**ADDENDUM
NO. 4**

**Whiteland Community High School Phase 1
300 E. Main Street
Whiteland, IN 46184**

**PROJECT: CLARK-PLEASANT COMMUNITY SCHOOL CORP.
WHITELAND COMM. HIGH SCHOOL ADDITION
PHASE 1: 3-STORY AND NATATORIUM ADDITION**

PROJECT NUMBER: 22130

S102AGH

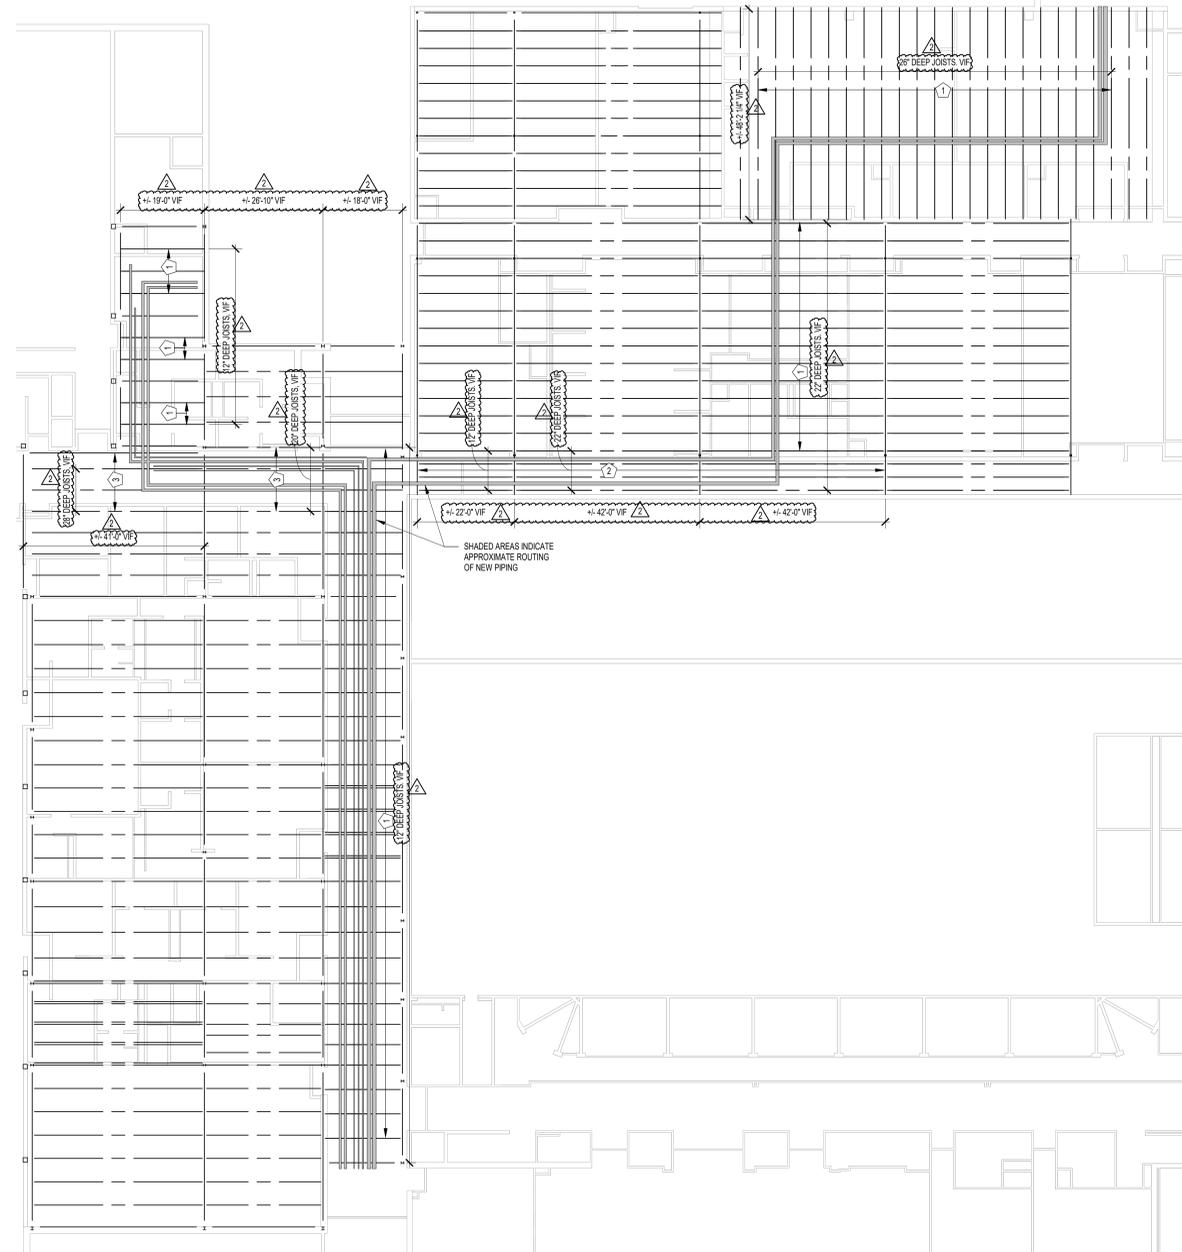
Q1: Detail 1/S602 requires joist reinforcement for the full length of the Joist for existing Joists in Unit E. We have not been provided with Unit E framing plans and cannot determine with accuracy the length of the existing joists that require reinforcement. By looking at S103L, we could guess that the existing joist length is ~34'-8" long and that they frame into a column line somewhere North of Line 12, but we don't know if all of those joists across Units L, K & J frame into that same column line?

1. Drawing Number: S102AGH
Drawing Title: EX. JOIST REINFORCING PLAN AND DETAILS
Revision:

Added length and depth of joists to be reinforced. All information will need to be verified in field.

A: See addendum 4 attached drawings.

- STEEL BEAMS DO NOT REQUIRE REINFORCEMENT.
BASED ON EXISTING DRAWINGS, THERE ARE 180-21" DEEP JOISTS THAT ARE 0'-3/4" LONG THAT WILL REQUIRE REINFORCEMENT. JOISTS NOT IN THE SHADED AREA DO NOT REQUIRE REINFORCEMENT.

S103J

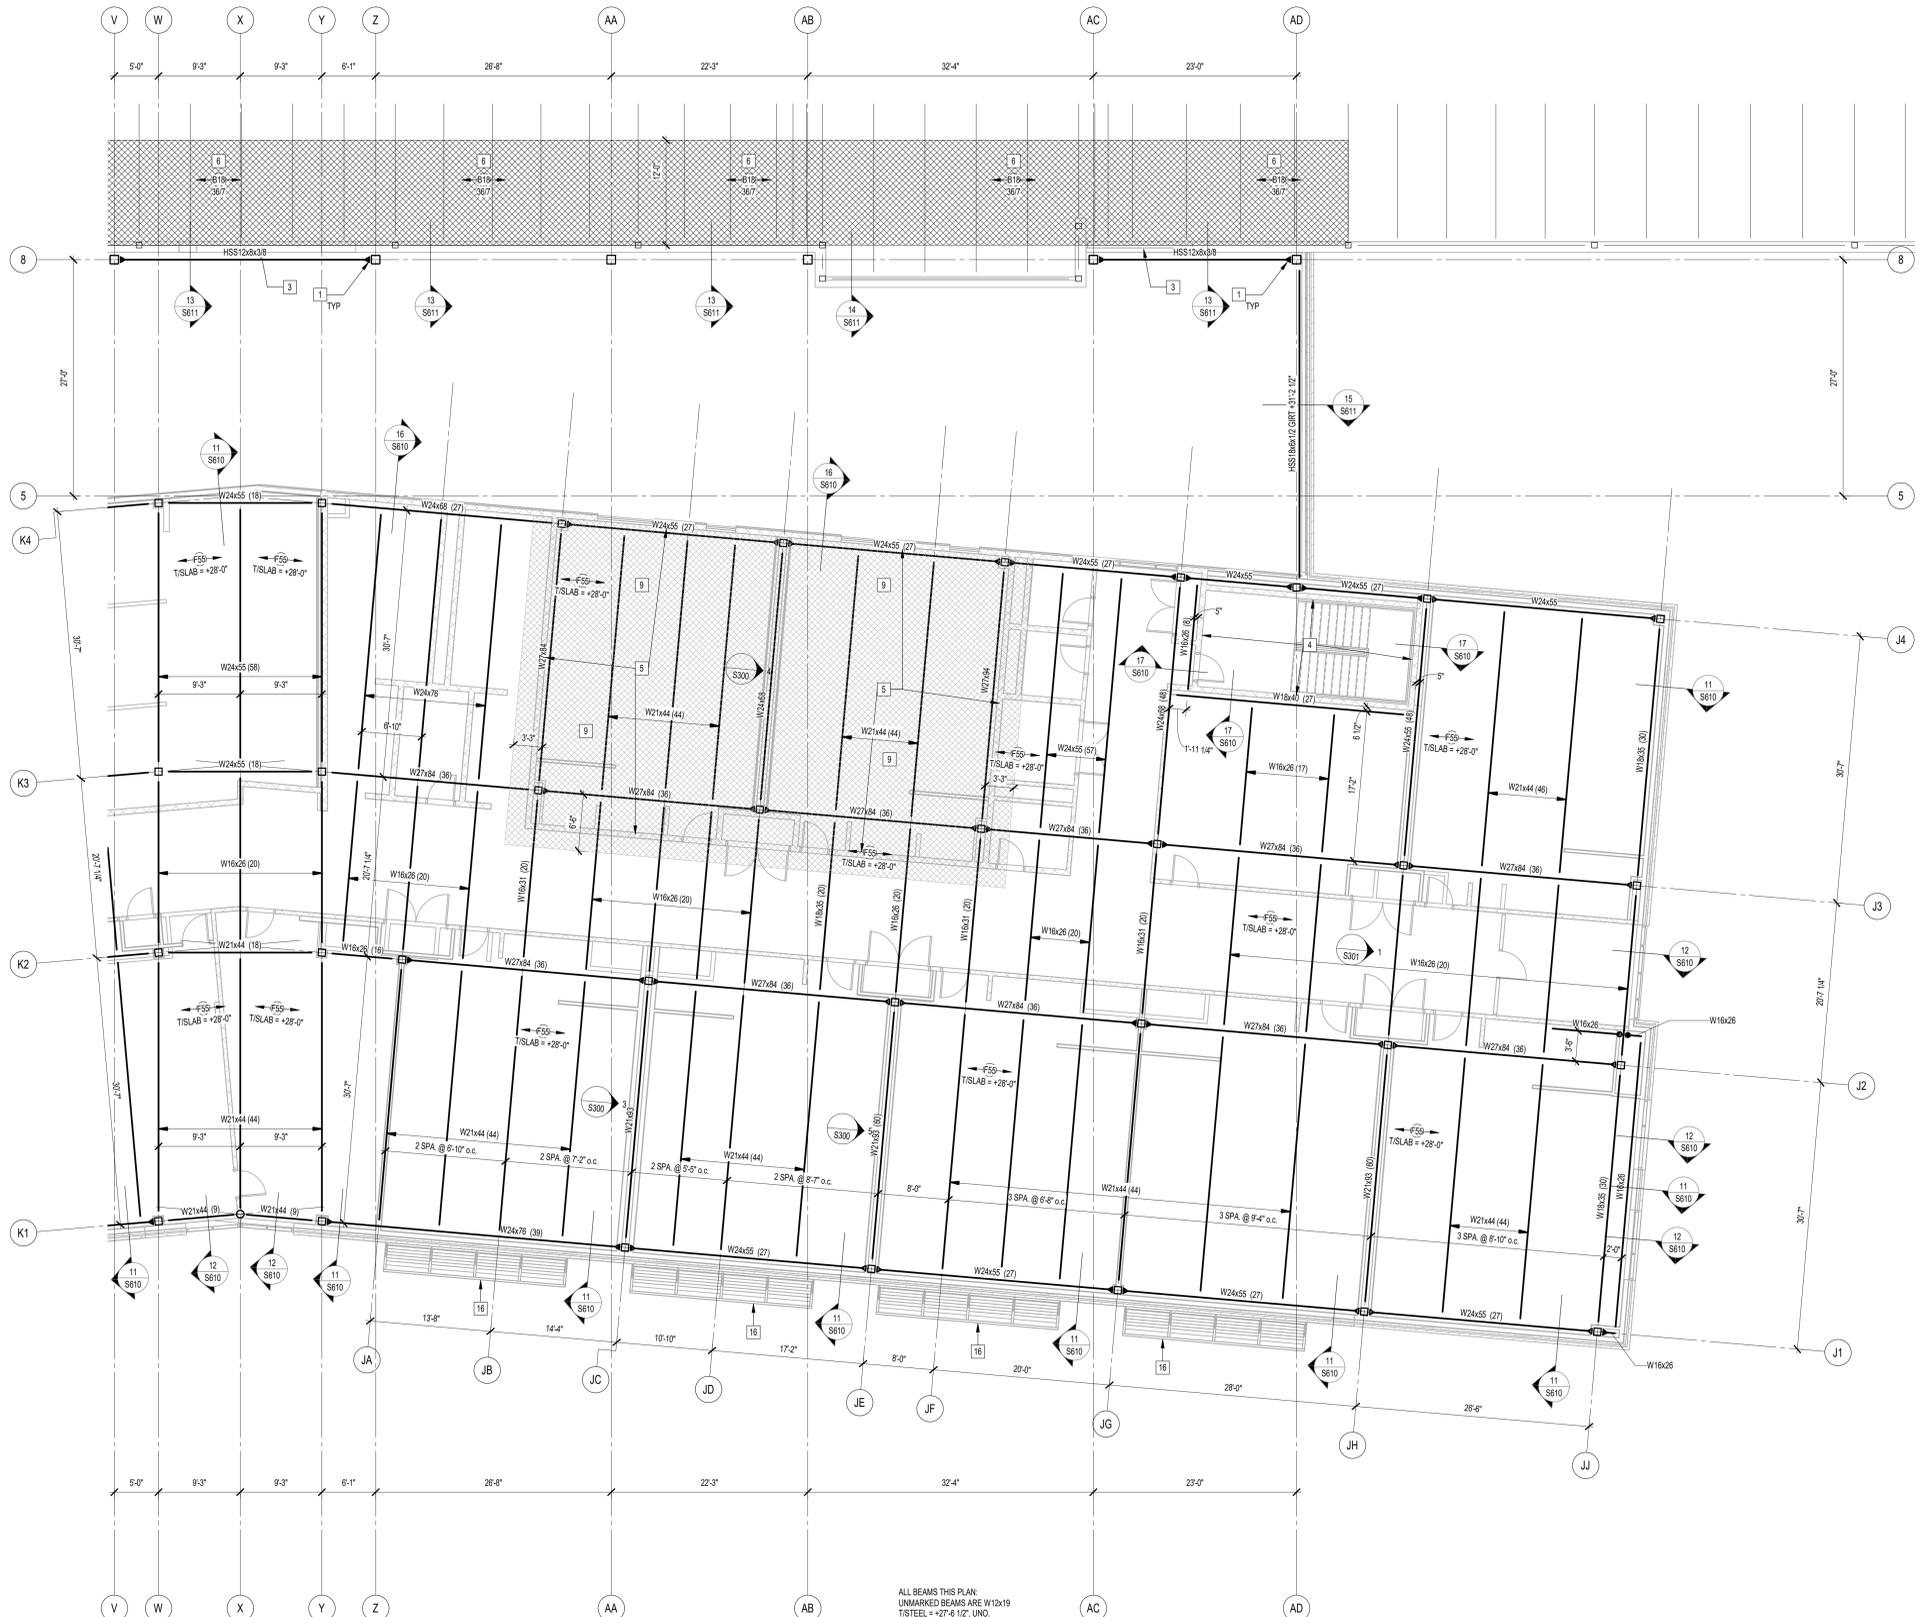
2. Drawing Number: S103J
Drawing Title: INTERMEDIATE ROOF & THIRD FLOOR FRAMING PLAN – UNIT J
Revision:

Updated Keyed Notes to provide quantity, length, and depth of joists to be reinforced. All information will need to be verified in field.

- STEEL BEAMS DO NOT REQUIRE REINFORCEMENT. BASED ON EXISTING DRAWINGS. THERE ARE 180-21" DEEP JOISTS THAT ARE 2'-3 3/4" LONG THAT WILL REQUIRE REINFORCEMENT. JOISTS NOT IN THE SHADED AREA DO NOT REQUIRE REINFORCEMENT. DASHED LINES INDICATE STEEL CHANNEL IN DECK FLUTES FOR MECHANICAL EQUIPMENT SUPPORT. CHANNELS ARE TO BE SPACED 48" o.c. MAX AND ARE TO EXTEND PAST EQUIPMENT SUPPORTS TO NEXT ADJACENT BEAM/JOIST.

S103K

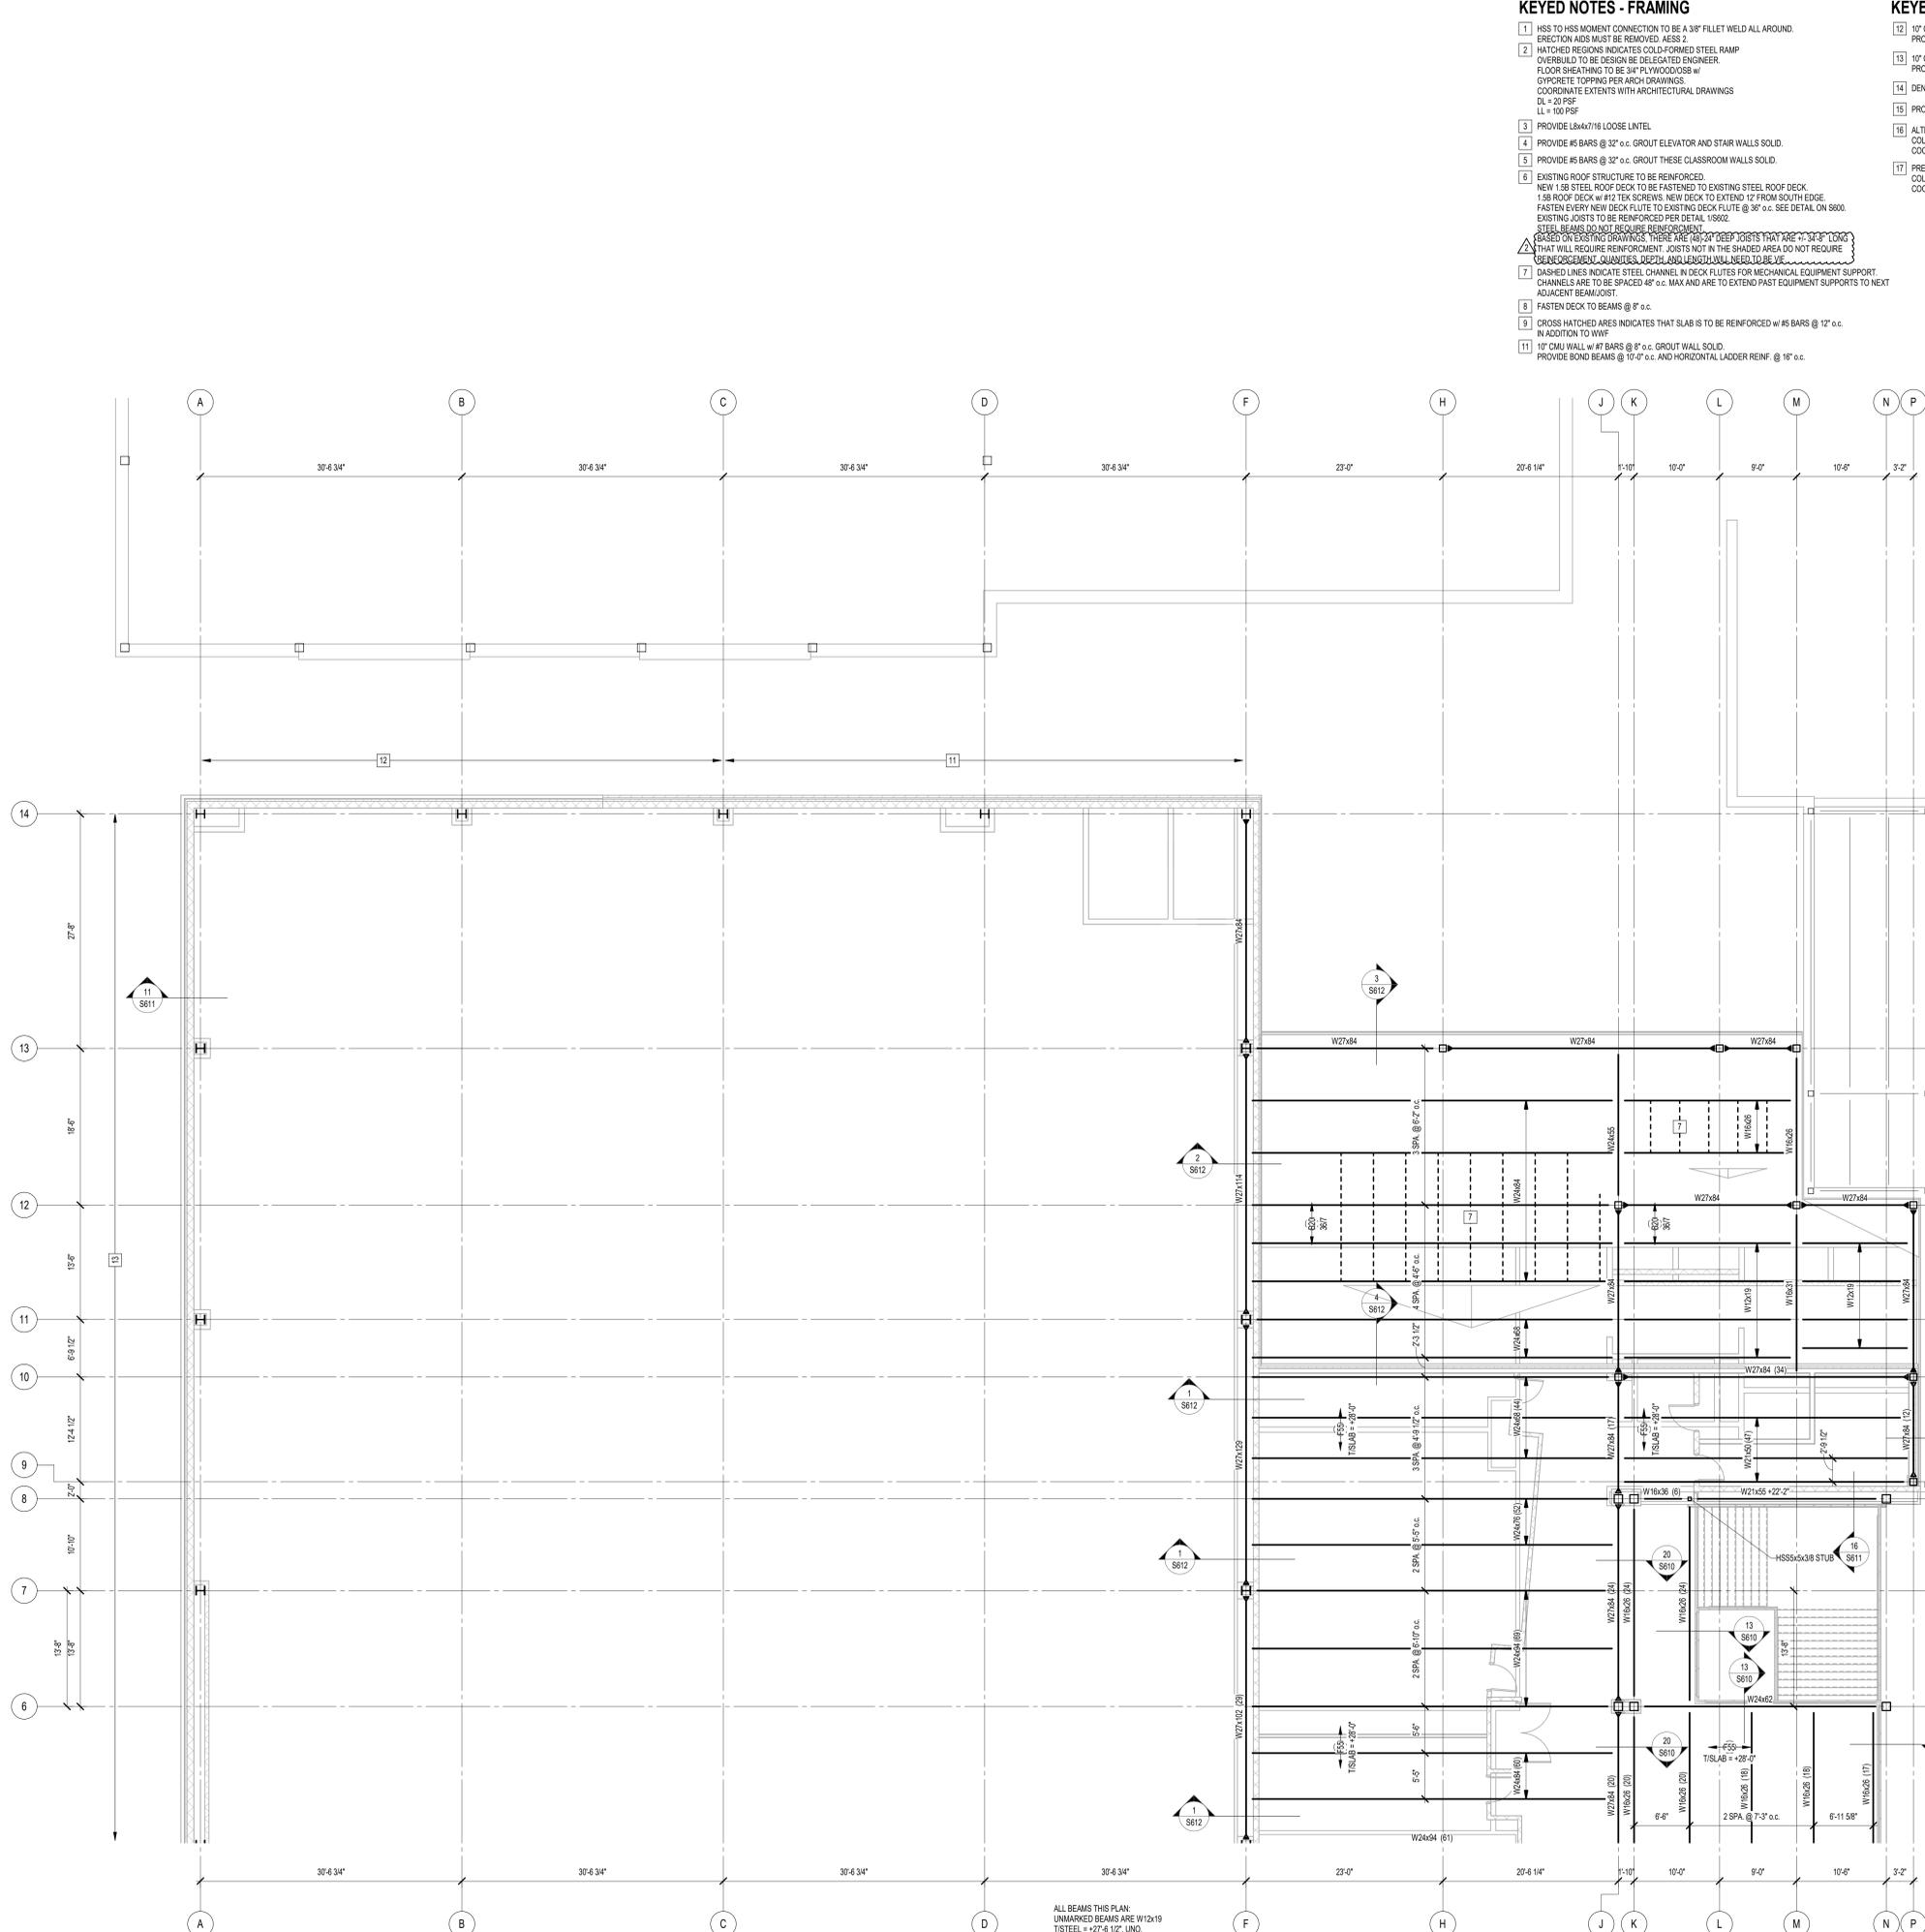
3. Drawing Number: S103K

Drawing Title: INTERMEDIATE ROOF & THIRD FLOOR FRAMING PLAN – UNIT K
Revision:

Updated Keyed Notes to provide quantity, length, and depth of joists to be reinforced.
All information will need to be verified in field.

- 7 STEEL BEAMS DO NOT REQUIRE REINFORCEMENT. BASED ON EXISTING DRAWINGS. THERE ARE 100-200 DEEP JOISTS THAT ARE 12-30" DEEP THAT WILL REQUIRE REINFORCEMENT. JOISTS NOT IN THE SHADED AREA DO NOT REQUIRE REINFORCEMENT.
